Springbank Reservoir Project
Alberta Transportation

Subject: Outcome of the review of Alberta Transportation's responses to federal information requests for the Springbank Off-Stream Reservoir Project

Springbank Off-stream Reservoir Project

Response to
Agency Conformity
Review of
Round 1 Part 3,
dated August 21, 2019

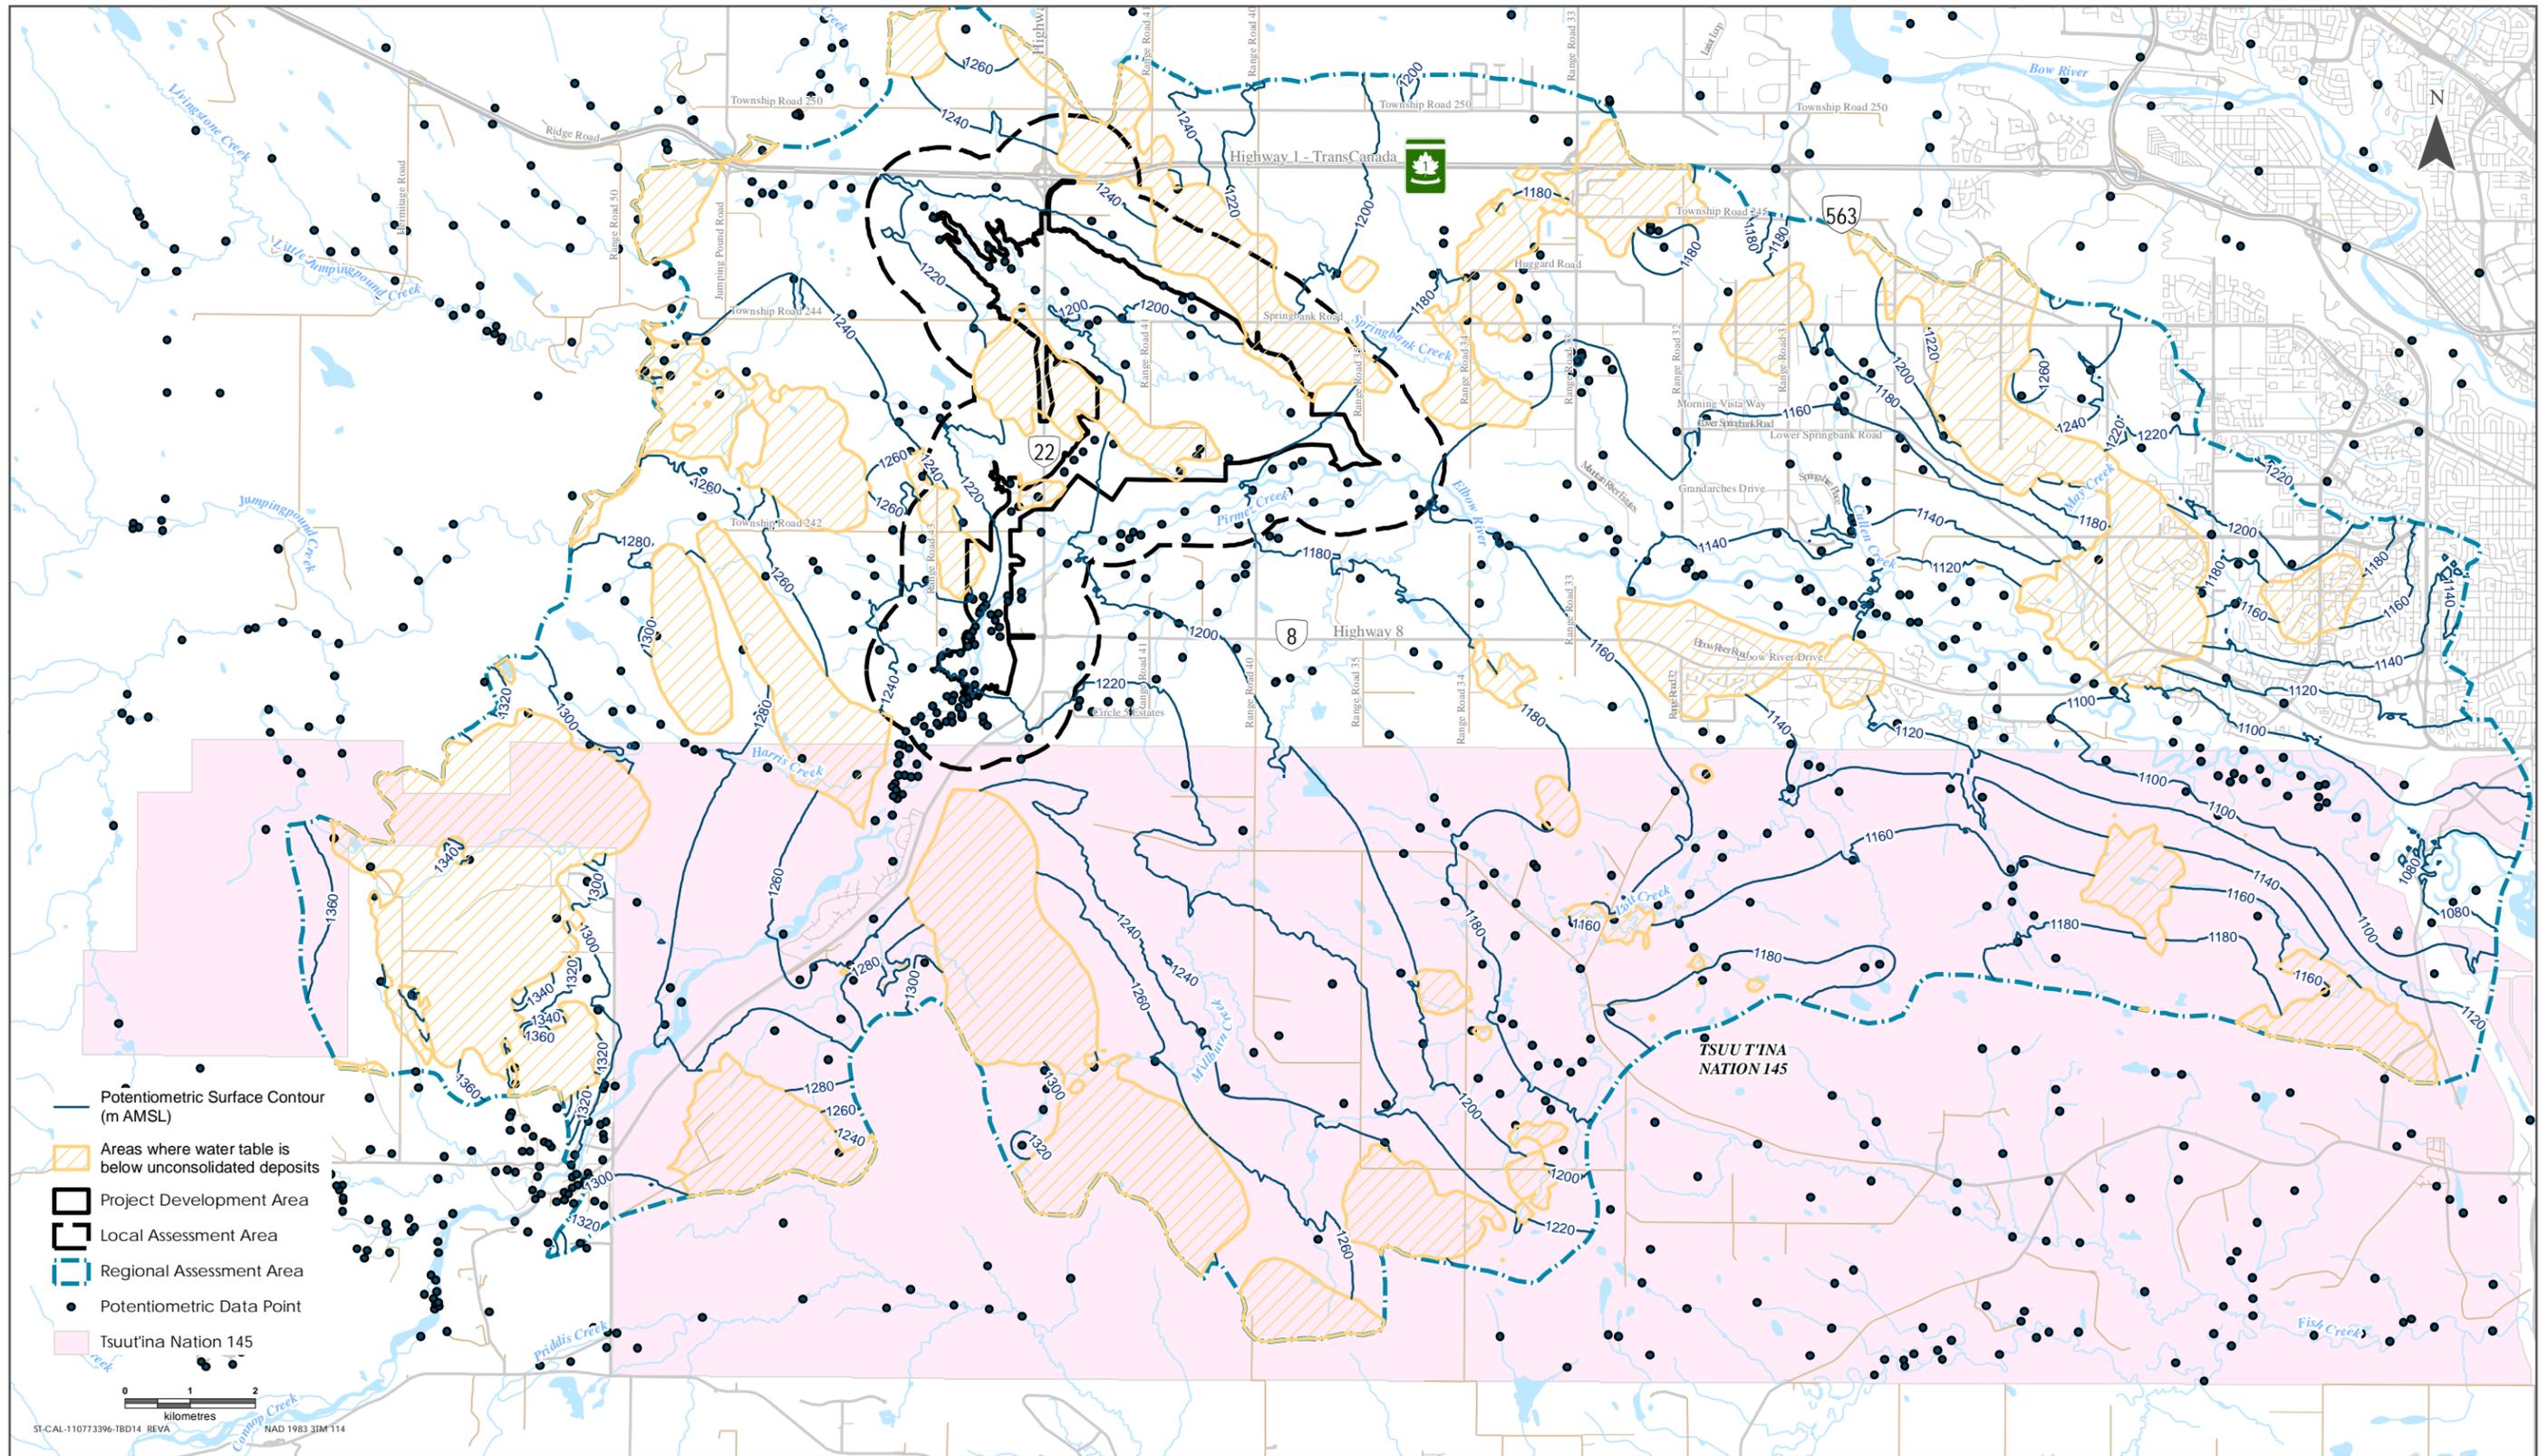
In IR3-18 b), the Agency required Alberta Transportation to identify all water level measurement locations used to map the potentiometric surface of unconsolidated deposits and clearly identify areas where the water table is below the unconsolidated deposits. It appears that a response to this IR is not provided.

- a) Concerns related to water level measurement locations are provided in the TDR Update, Section 3.2.2. All water level measurement locations used to map the potentiometric surface of the unconsolidated deposits are presented in the TDR Update in Figure 3-19. Figure 18-1 (modified from Figure 3-19 of the TDR Update) is provided here.

Figure 18-1 identifies areas where the water table is below the unconsolidated deposits. The potentiometric contours have been removed from unsaturated areas of the unconsolidated deposits. The graphical representation of this information is not a concern for the new model.

Figure 24-1

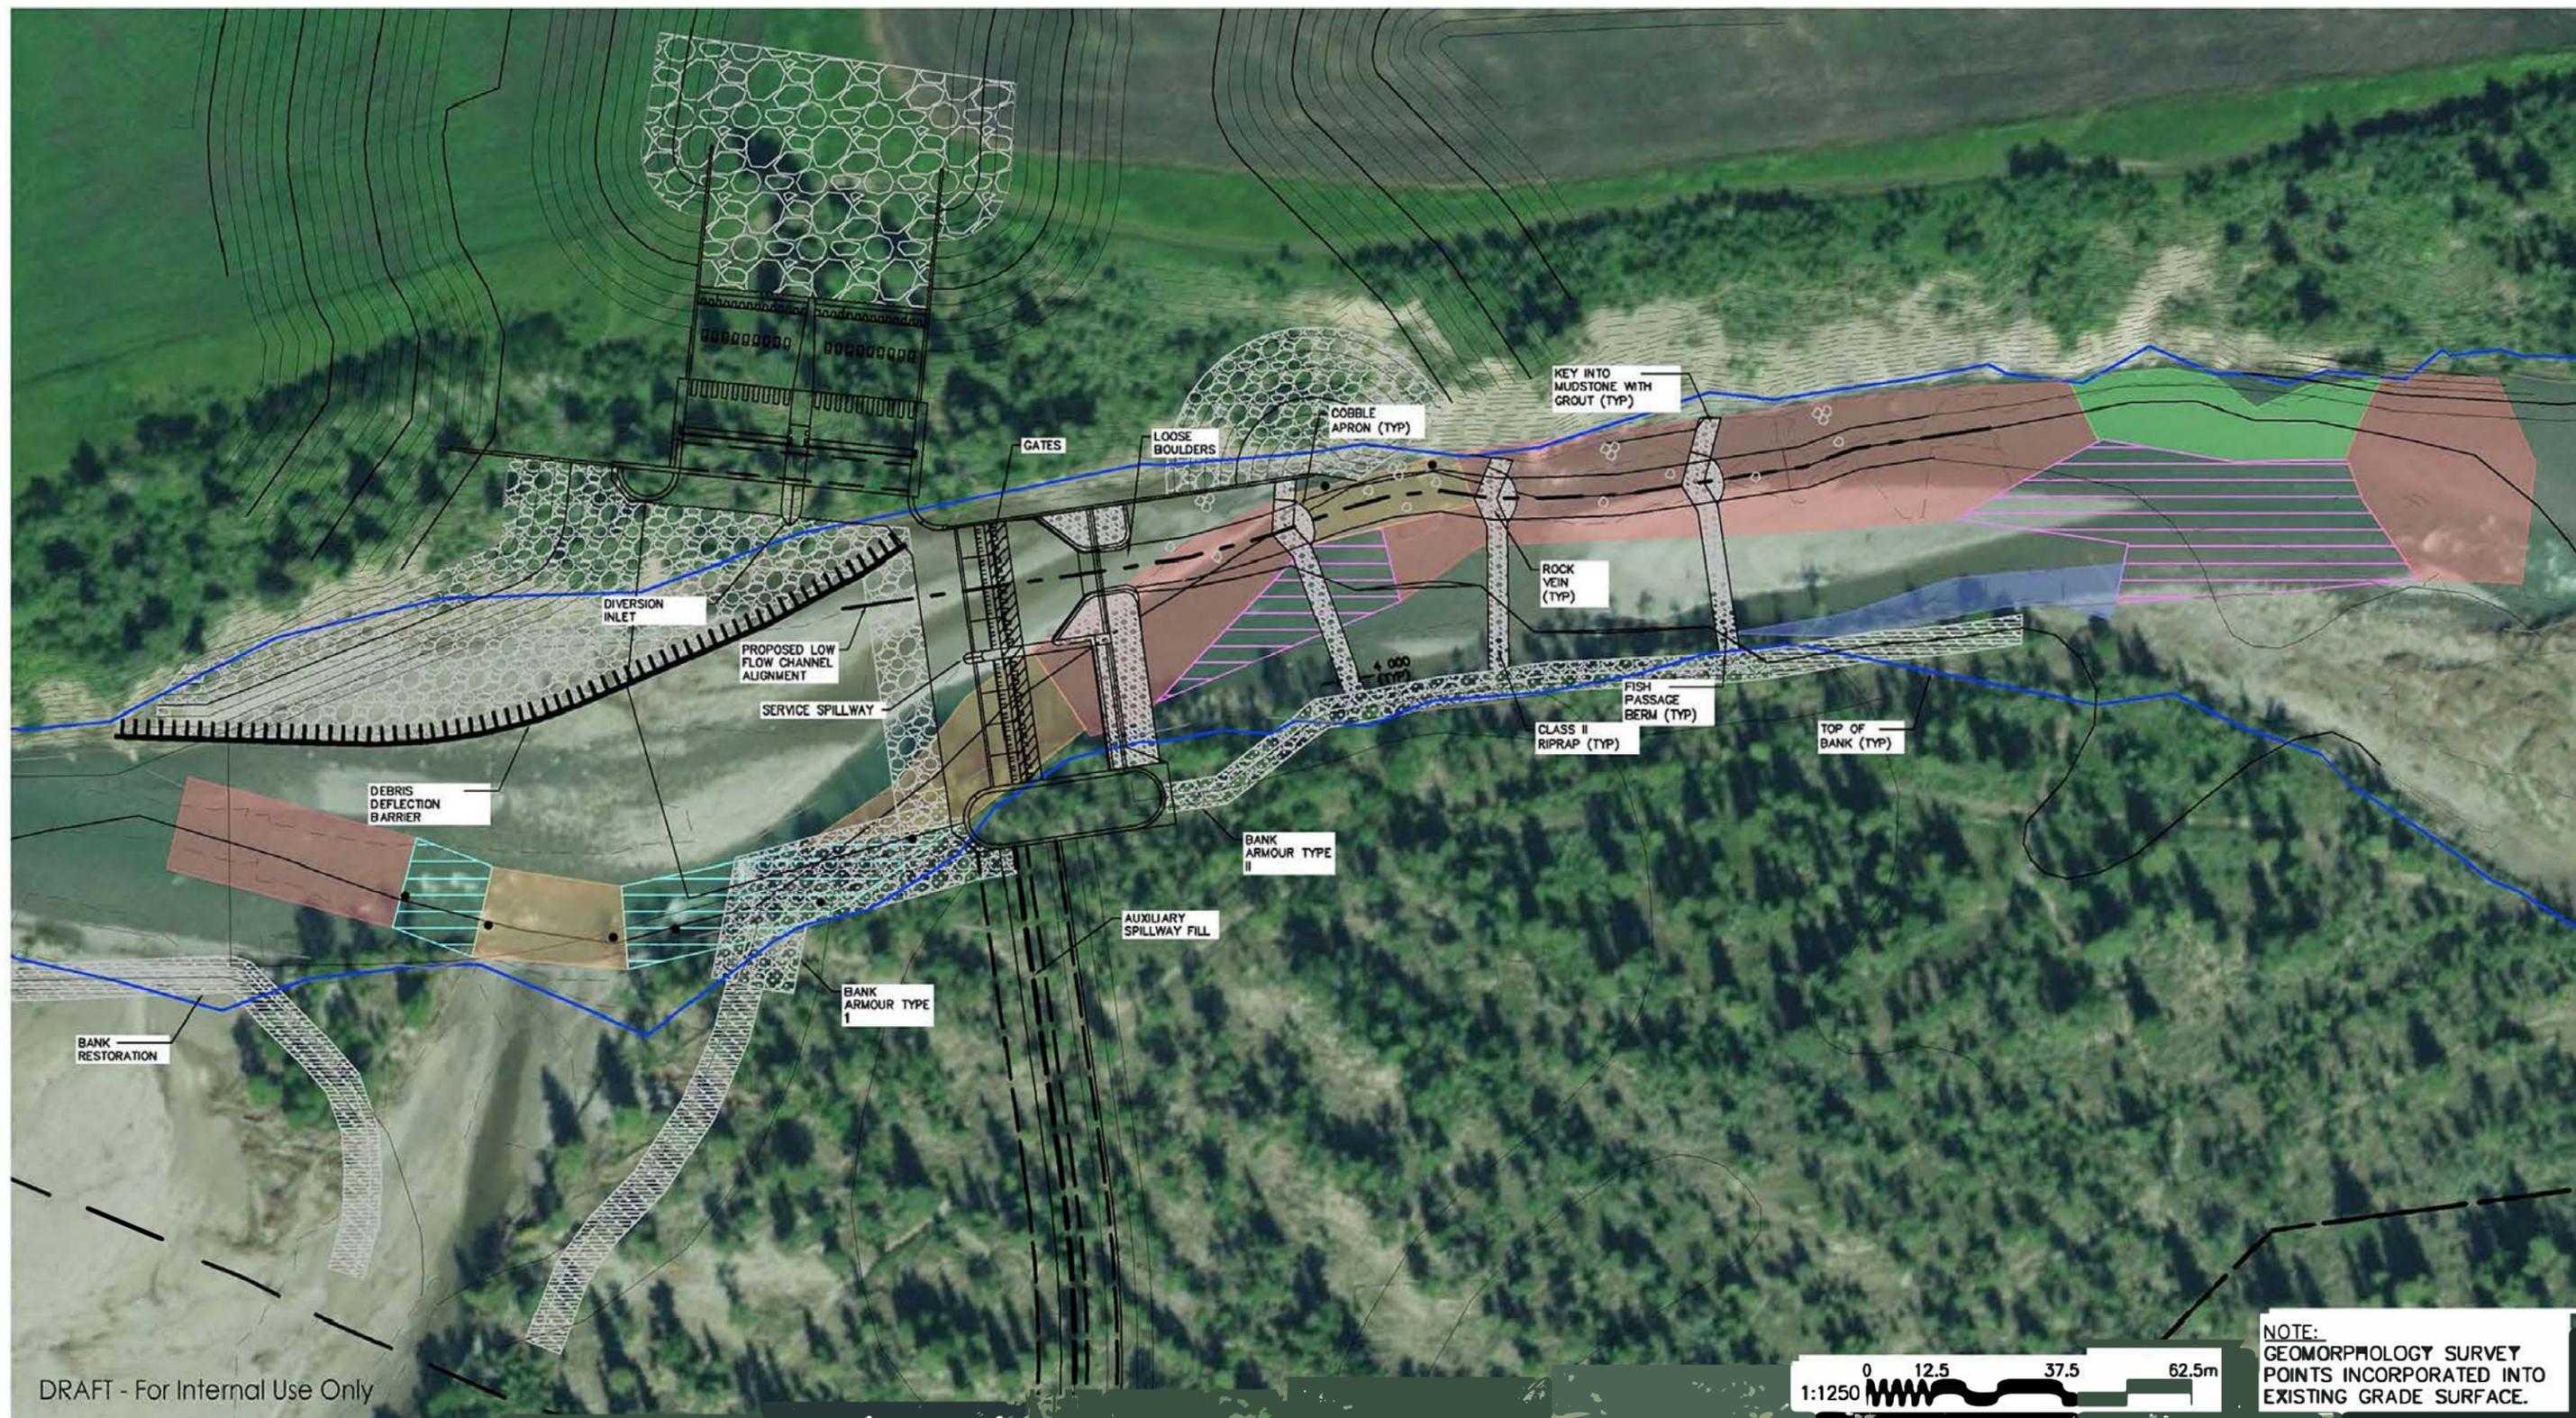
Alberta Transportation's response to IR3-24 states that an analysis of the habitat footprint associated with the planned diversion structure and Highway 22 bridge has not been completed and will be generated for an application for authorization to Fisheries and Oceans Canada (DFO). The response quotes the EIS and does not offer additional rationale for the characterization of residual effects. Sufficient information is required within the environmental

Alberta Transportation's response identifies, to the extent possible given the design completed to date, an overview of the habitat types that overlap with project components and physical activities and the associated permanent alteration or destruction of fish habitat. The response does provide not an equivalent breakdown of areas to be affected by Project operations or describe the interconnection between the placement of temporary or permanent structures, the operations of these structures, and effects to fish and fish habitat. For example, the response states that the diversion structure will affect Class 3 run and riffle habitats within the thalweg of the Elbow river; however, the response does not explain how the operation of the diversion structure, specifically the obermeyer gates, and the design of fish passage mitigation measures to constrict flow to the thalweg on the north bank of the river may affect potential spawning riffle downstream of the diversion structure.

- a) Project components and associated aquatic habitat in the footprint area are listed in Table 24-1. The information relevant to the footprint area in Elbow River is also illustrated in Figure 24-1. The relationship (i.e., interconnection) between the placement of temporary and permanent structures, the river channel morphology, and fish habitat is dependant on dynamic river processes. Instream changes due to Project infrastructure will affect stream flows that rearrange mobile substrates, thus redistributing or changing the nature of channel units and effects on fish habitat.

the bed structures within the channel includes areas considered bar habitat and unavailable for much of the year and therefore, potential footprint related effects are low. Figure 24-1a illustrates the habitat types in relation to Project footprint components.
